## YEAR 5 OF 5 MONITORING REPORT - FINAL

**Five-Mile Branch Stream and Wetland Restoration, Iredell County  
NCDMS IMS ID# 92185**

**Responses to Comments**  
**Draft Year 5 Monitoring Plan**  
**for**  
**Five Mile Branch Stream and Wetland Restoration Site**  
**NCDMS IMS ID # 92185**  
**DEQ Contract# 6036**  
**Comments and Responses**

Photo Point

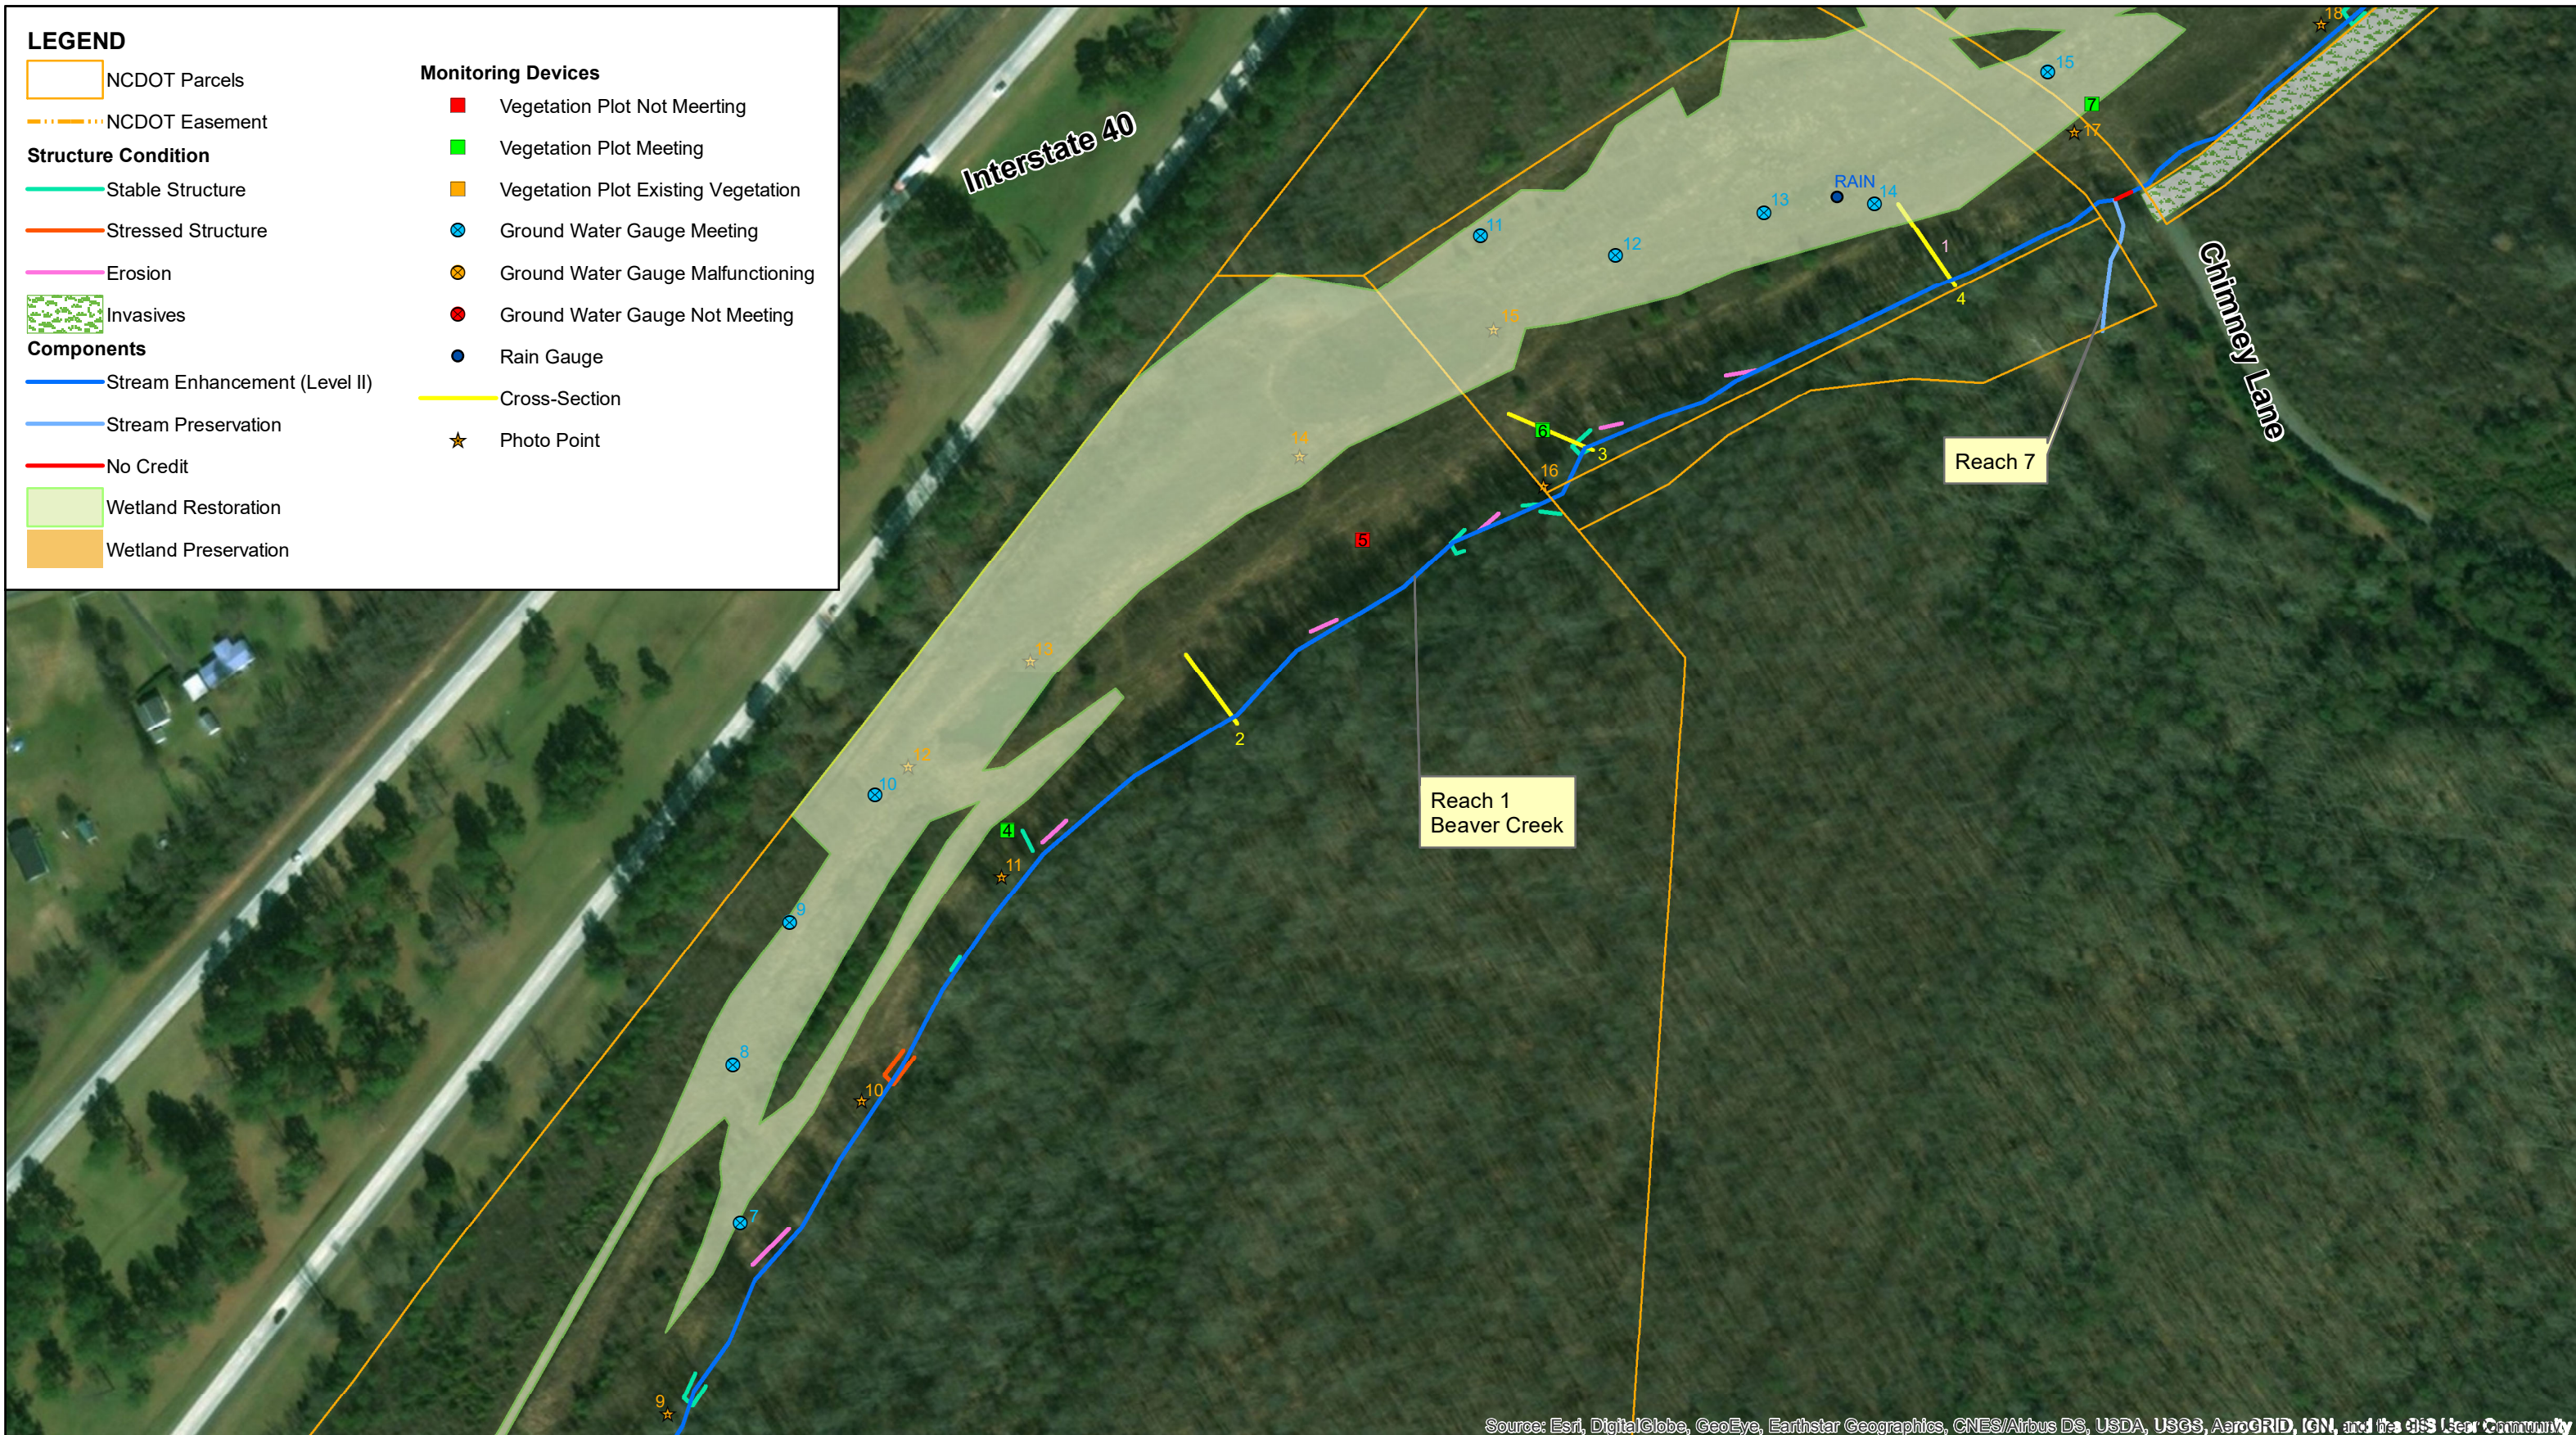
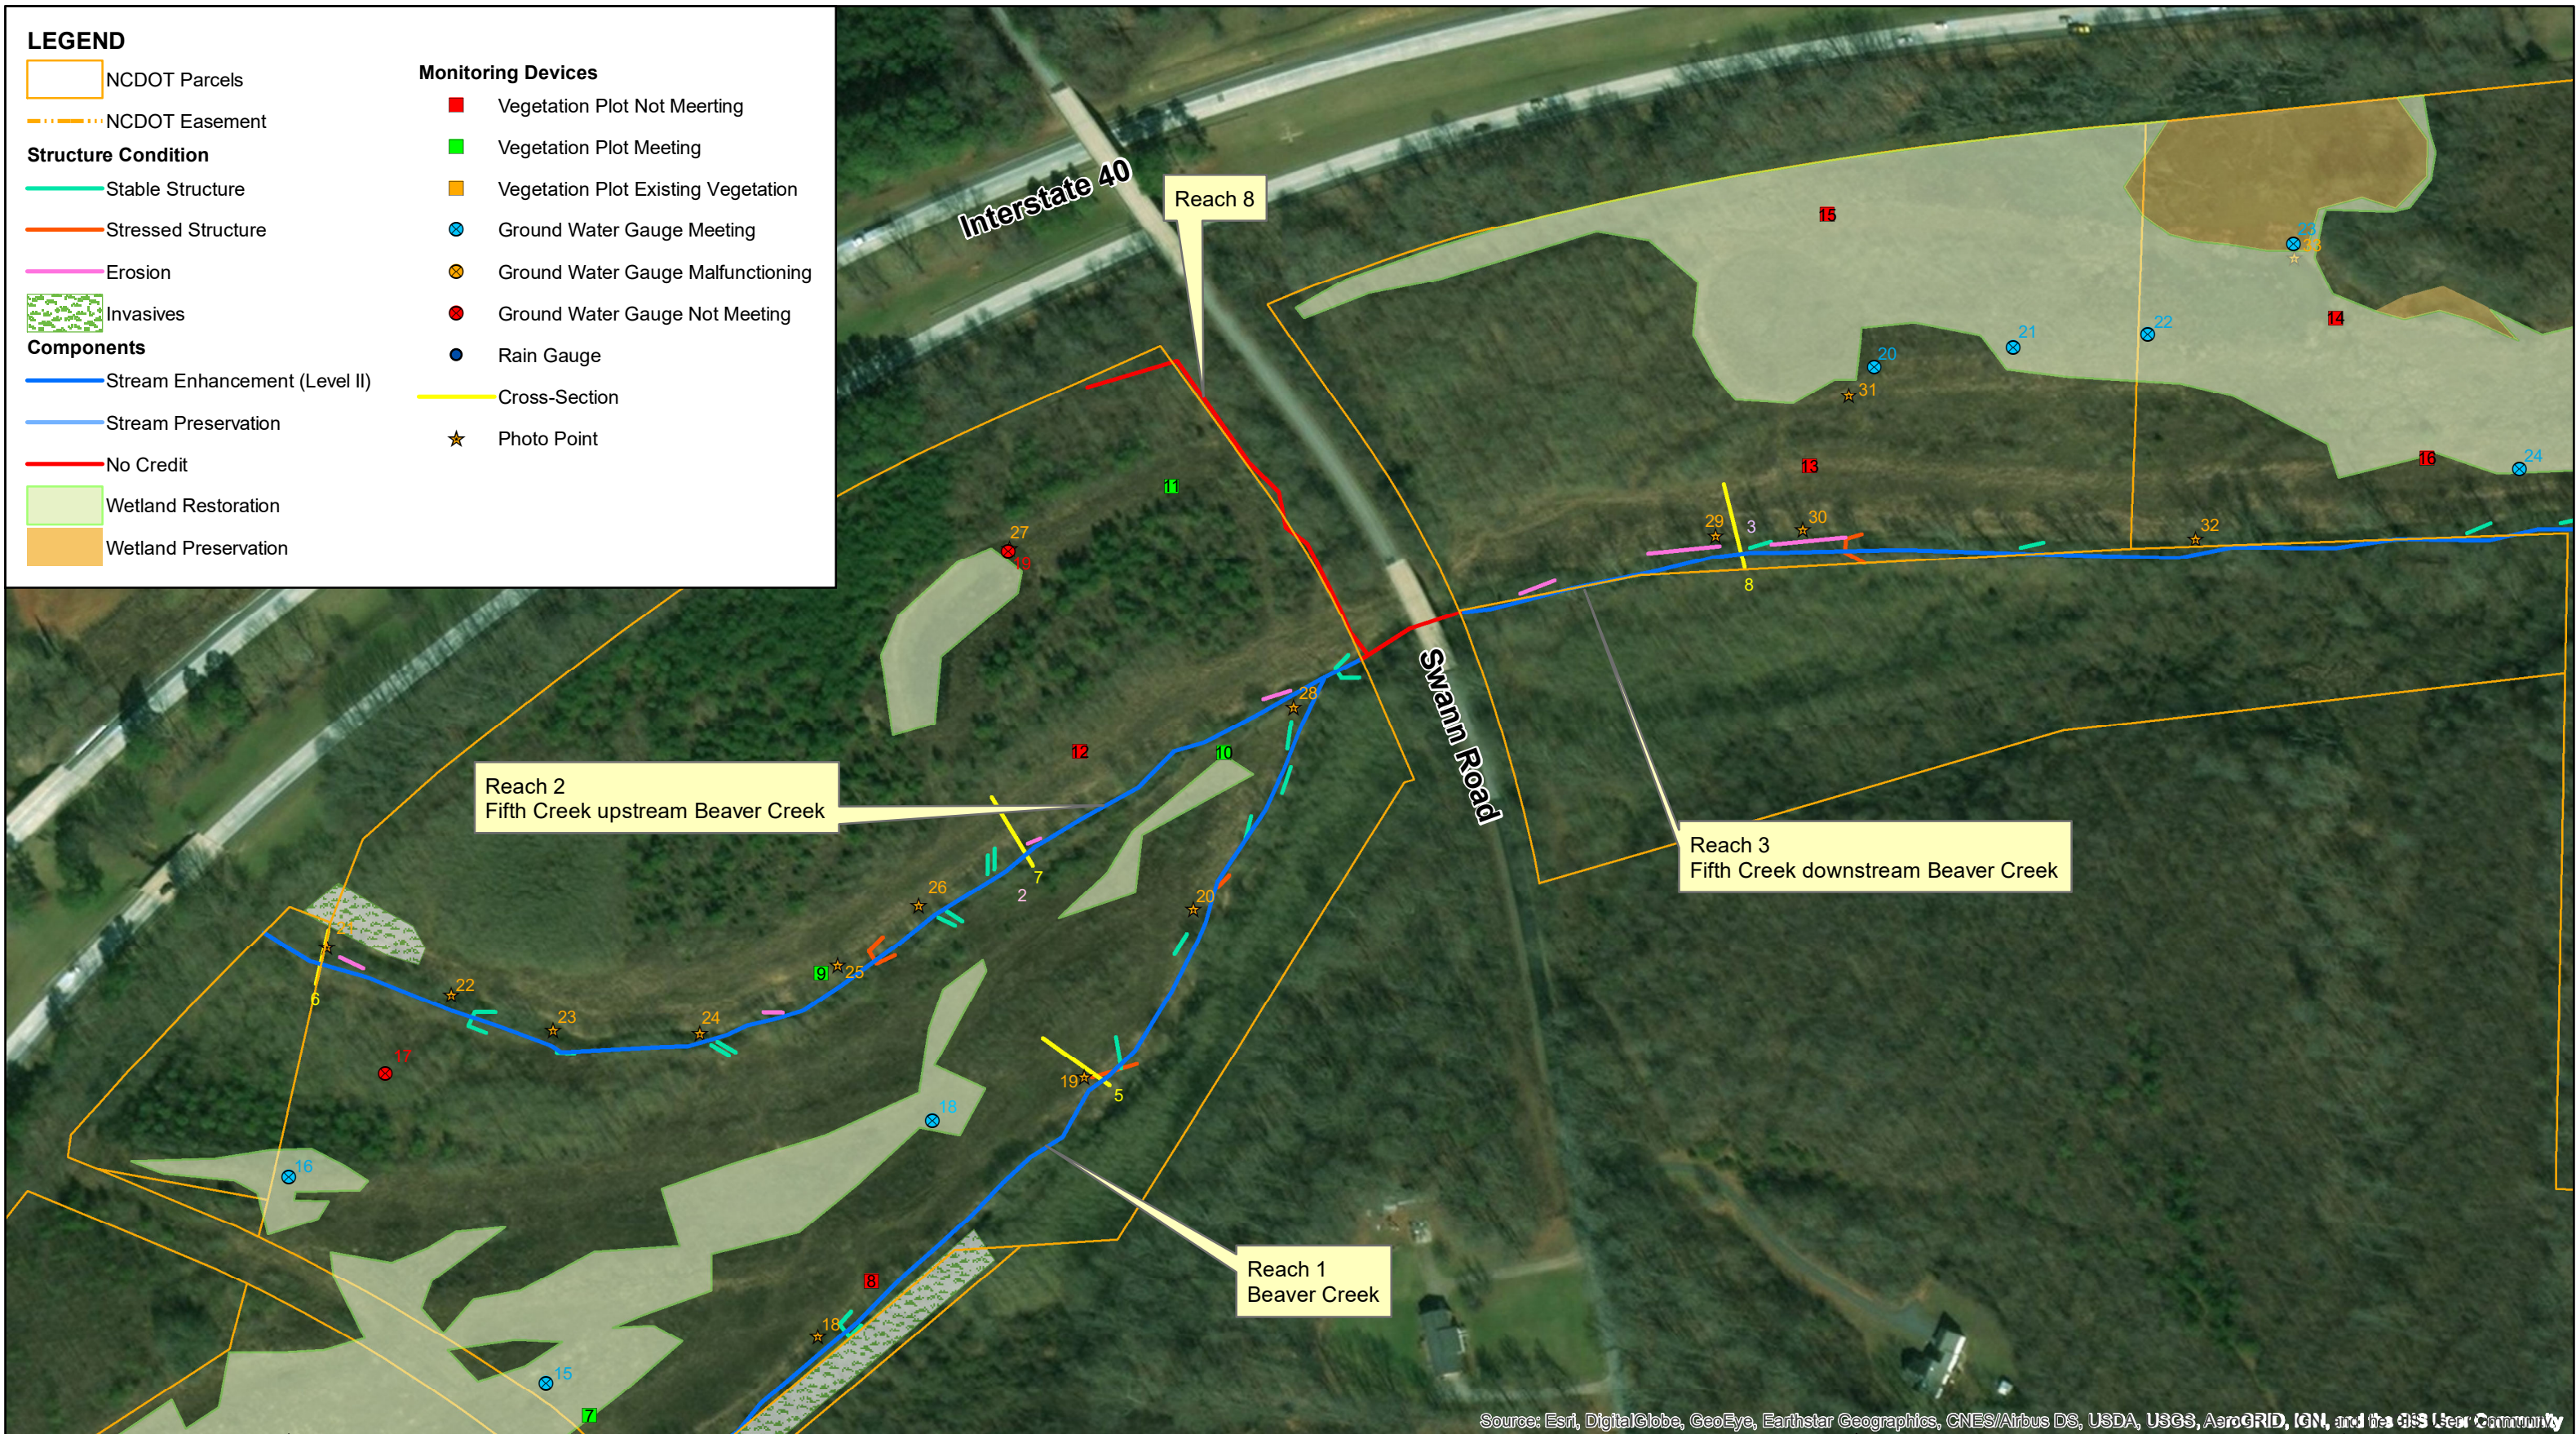
legend. Please terminate stream shapes that are located outside of the project boundary to avoid confusion about project credits.	
012	<b>CCPV Sheets:</b> Please remove the "Year 4 Wetland Delineation" label from the map legend. The project wetlands should be shown/ shaded as "Wetland Restoration" & "Wetland Preservation" with different colors to represent each approach on the maps and in the legends.	The CCPV Sheets were updated.
013	<b>CCPV Sheets:</b> Please include the preservation streams on the CCPV sheets. Please also provide stream names and mitigation approaches (EII; Pres) on the CCPV sheets.	The CCPV Sheets were updated.
014	<b>CCPV Sheets:</b> Please update the aerial to the most recent available.	The CCPV Sheets were updated.
015	<b>CCPV Sheets:</b> If mapped invasive areas have been treated and are dead, please removed them from the CCPV sheets. If updated on the CCPV sheets, please make sure to update Table 6 as well.	The CCPV Sheets were updated.
